dsPIC33CK256MP508 Family Silicon Errata and Data Sheet Clarification

The dsPIC33CK256MP508 family devices that you have received conform functionally to the current Device Data Sheet (DS70005349K), except for the anomalies described in this document.

FIGURE 1-1: I/O RAMP

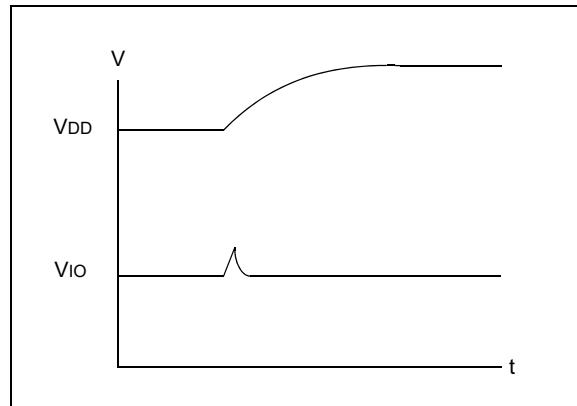
24. Module: I/O

During a fast device power-up when the VDD ramp is less than 4 mS, the I/O pins may drive up to 100 μ A current for a duration of up to 10 μ S (Figure 1-1).

Work around

1. Slow down the VDD ramp time (greater than 4 mS for VDD to ramp 0V to 3.3V).
2. Ensure the circuitry that is connected to the pins can endure this pulse.

Example applications affected may include complementary power switches, where a transient current shoot-through might occur. High-voltage applications with complementary switches should power the high-voltage 200 μ Sec later than powering the dsPIC® device to avoid the current shoot-through. This behavior is specific to each device and not affected by aging.
